**Federal Highway
Administration**

In Reply Refer To: HSA-10/CC-73C

Mr. Douglas Bernard recently delivered your April 19, 2006, letter to Mr. Richard Powers of my staff. In this letter you requested the Federal Highway Administration (FHWA) acceptance of a low-speed Wide REACT at NCHRP Report 350 test level 1 (TL-1). The configuration of this unit is similar to your TL-3 and TL-2 Wide REACT designs that have been previously reviewed and accepted by the FHWA (reference acceptance letters HSA-10/CC-73, CC-73A and CC-73B). To support your request, you included drawings of the new unit with widths of 60" and 96", a chart listing the kinetic energy dissipating capacities of common REACT cylinders used to assemble these systems and a figure listing the estimated energy-absorption capacities of your TL-2, TL-3 and proposed TL-1 units. Also included, as reference, were copies of one-page summaries from previously accepted (60"/96") TL-2 and (60"/96"/120") TL-3 Wide REACT tests.

FIGURE 1

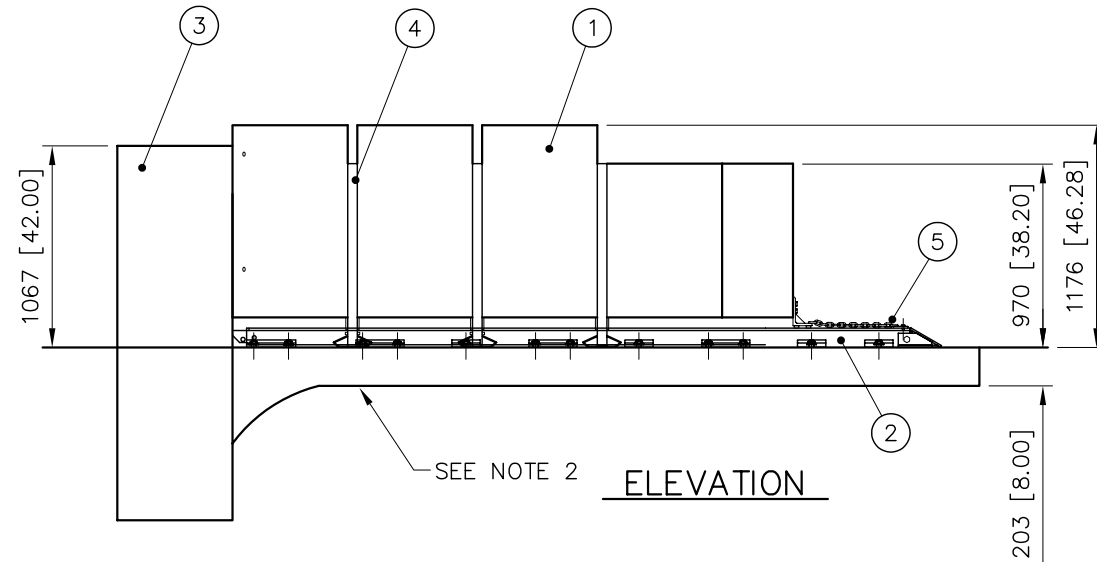
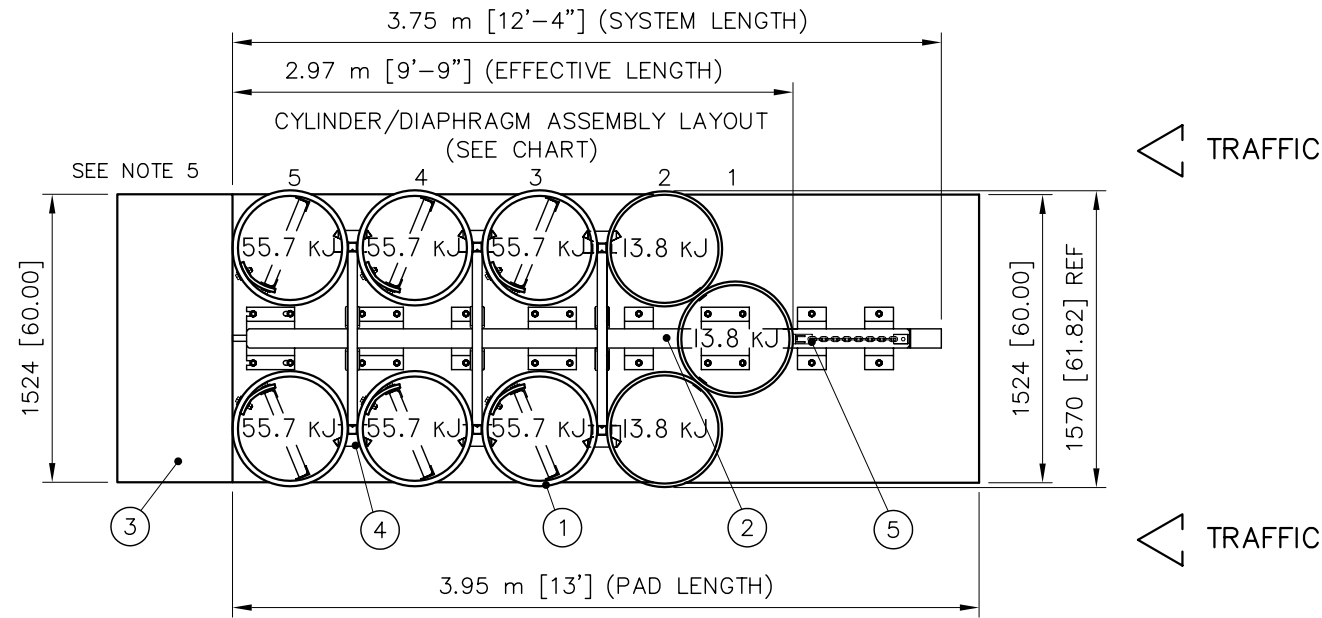
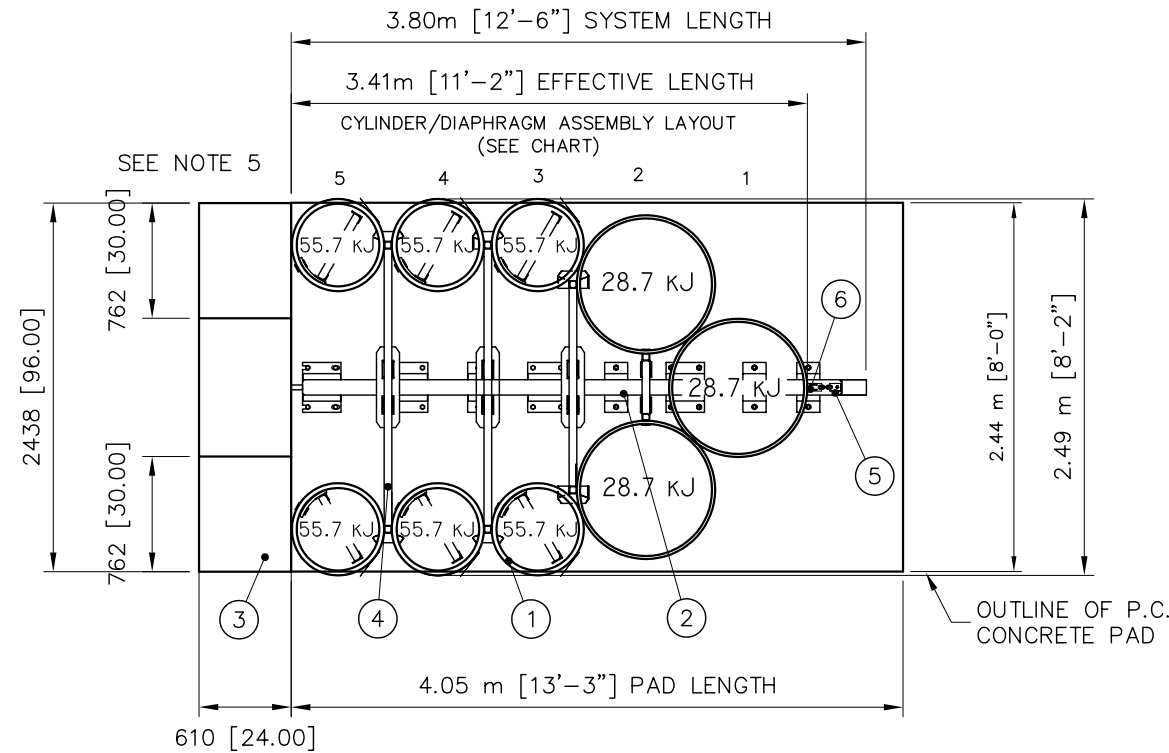
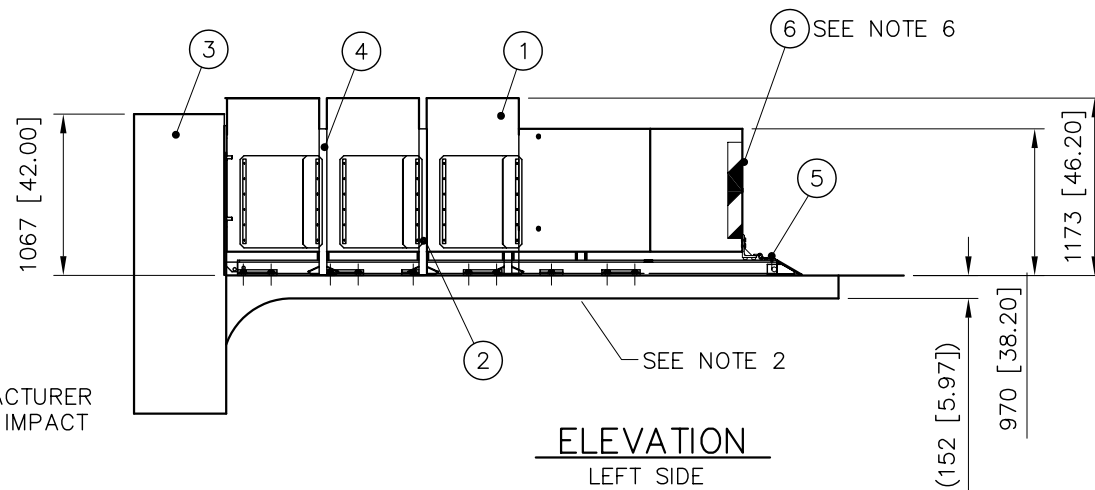
The TL-1 Wide REACT is a redirective, non-gating crash cushion having an effective length of 3.23 m (10.6 feet). It can be configured with backup widths from 1524m (60") to 2440 (96") as shown in Enclosure 1. Because the TL-1 REACT has essentially the same framework and components as the previously accepted TL-2 and TL-3 Wide REACTs, we agree that the low-speed designs may be assumed to meet the National Cooperative Highway Research Program Report 350 evaluation criteria at TL-1 without additional testing and can be used on the National Highway System (NHS) when such use is acceptable to the contracting authority. However, it is critical that they be used only in locations where impact speeds are not expected to exceed 50 km/h (30 mph) or in locations where a higher-capacity, longer crash cushion cannot be installed due to space limitations.
